**Response to U.S. EPR Design Certification Application RAI No. 349, Supplement 21**

**Request for Additional Information No. 349, Supplement 21**

**U. S. EPR Standard Design Certification**

**SRP Section: 19 - Probabilistic Risk Assessment and Severe Accident Evaluation**

**Figure 19-334-1—Jet Velocity Distribution**

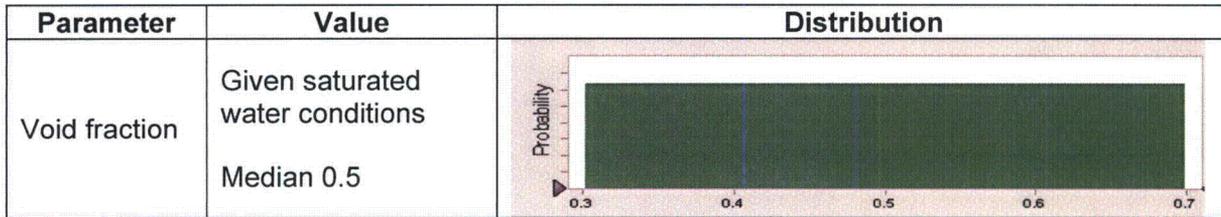
- a) Please revise the ex-vessel steam explosion analysis to reflect the potential impact of phenomenological uncertainties, especially, during the pre-mixing phase of a steam explosion.
- b) In addition, please discuss the consequences of steam explosions from delayed relocation of core debris from the reactor vessel (following pit plug melt-through) on the structural integrity of the pit, transfer channel, the spreading area (including the debris cooling structures), and the containment.

The distribution from Table 1 of Reference 2 was used. This distribution is adapted to the central leak scenario as the maximum jet velocity calculated from the geometry of the melt in the RPV at the time of failure is [ ]. However, for the lateral RPV failure scenario the maximum calculated velocity is [ ] because of the lower depth of melt above the breach location. Therefore, the distribution from Reference 2 is shifted toward a lower range for the lateral leak scenario that is better representative of this case. Figure 19-334-1 shows the jet velocity distribution.

**Figure 19-335-1—Primary System Pressure for Multiple Steam Generator Tube Ruptures**

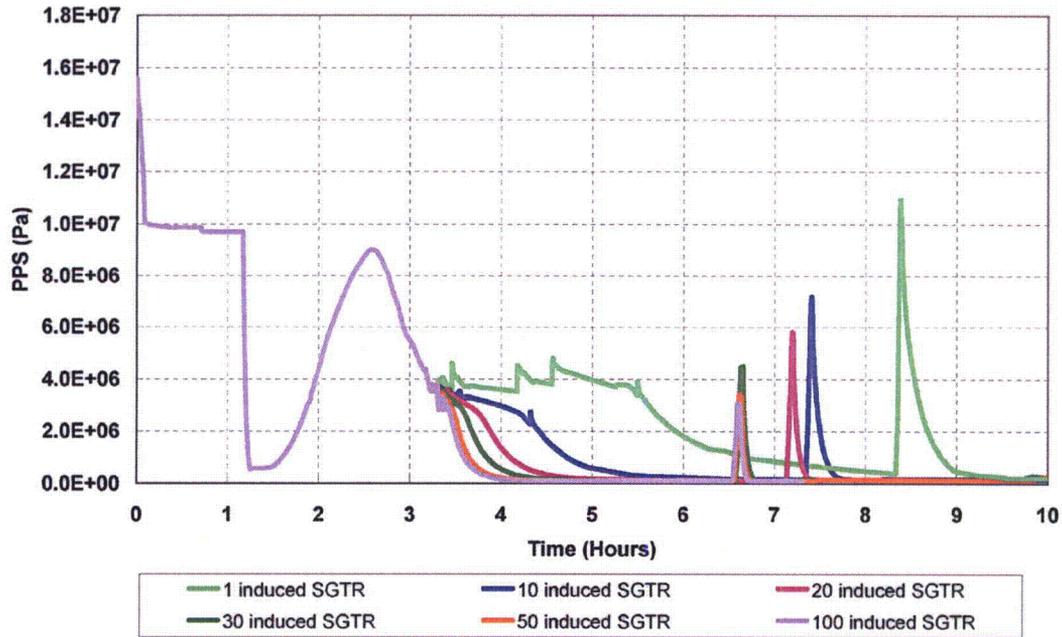
- a. Please revise the analysis to reflect the potential impact of continued heatup of the steam generator tubes, and determine at what level of failure (number of tubes), RCS depressurization occurs, terminating additional tube failures.
- b. Please extend the present source term calculations to at least 48 hours, and report the impact on fission product releases and severe accident risk for U.S. EPR.

A number of modular accident analysis program (MAAP) runs have been performed with an increased number of SG tube failures. Figure 19-335-1 shows the primary system pressure for a single and multiple SGTRs; 1, 10, 20, 30, 50 and 100. Figure 19-335-2 shows the maximum wall temperature for SG tubes as a function of time after a given number of tube ruptures.

Figures 19-335-1 and 19-335-2 show that adequate depressurization and cooldown of the SG tubes is reached with a break area equivalent to the rupture of a maximum of 20 tubes, assuming that no induced hot leg rupture (IHLR) occurs. If IHLR occurs at any time after the initial tube rupture, additional SGTRs will be precluded due to the rapid and complete depressurization of the primary system leading to a stress relief across the tubes and their cool down.

**Figure 19-335-4—Fission Product Releases for 48 Hours Following a Single Induced-SGTR**

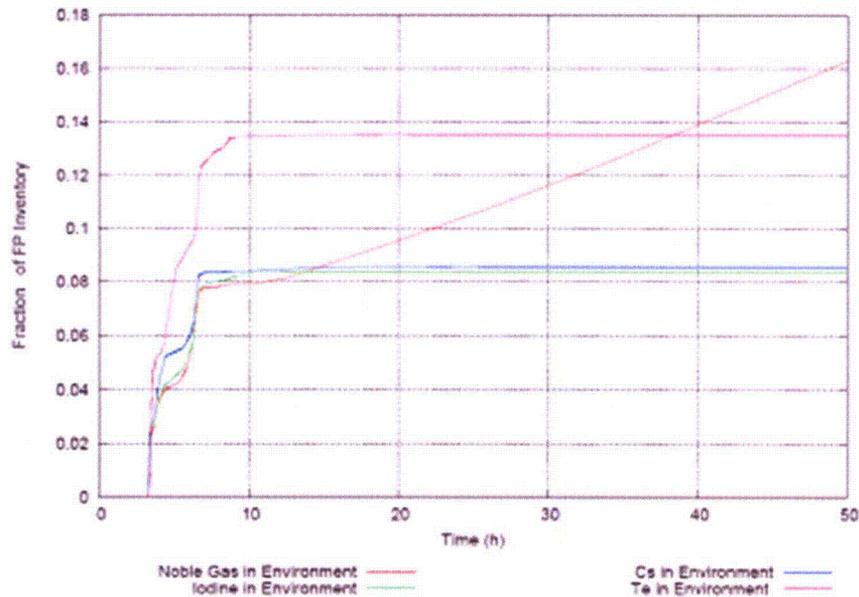
The calculated fission product releases to the environment for the single and multiple tube failure based on MAAP results are low. In comparison to the recent NRC MELCOR calculations for a single double-ended induced-SGTR scenario, the MAAP results cited in AREVA response, are about 50% too low. One reason is the termination of MAAP calculations after 24 hours, thus limiting the releases due to revaporization. These differences are significant and need to be reconciled.

Figure 19-335-4 shows the original MAAP4 results of fission product releases for the single induced-SGTR scenario extended out to 48 hours. These releases are approximately half of the values determined by the NRC MELCOR analysis with no appreciable change in the time period from 24 to 48 hours for the volatile fission products, data provided in Table 19-335-2.
